HOLLAND® Fifth Wheels

Notice of Redesigned FW17 Fifth Wheel Model Effective October 2020

This product notice applies to the FW17 Fifth Wheel Top Plate.

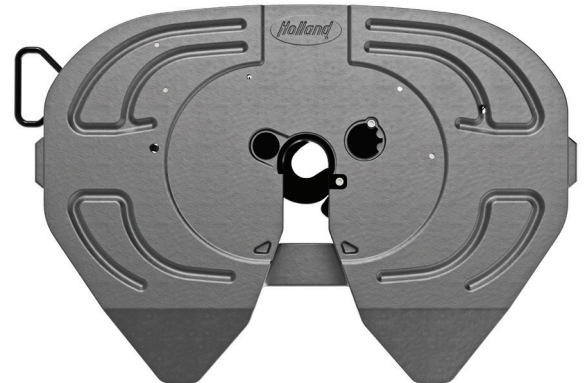
The FW17 Fifth Wheel will now include a highly optimized ductile iron top plate, a replaceable front lock, and improved lock mechanism functionality. The engineers at SAF-HOLLAND improved this fifth wheel with features like a wider throat for easier couplings and improved maintenance efficiencies that make the new design easier to rebuild. The new FW17 is also easier to retrofit with optional air release due to integrated mounting holes and common components.

- Cast Ductile Iron Material
- Replaceable Front Lock
- Wider Throat for Easier Coupling
- Larger Diameter Mounting Pins w/ Revised Bushings
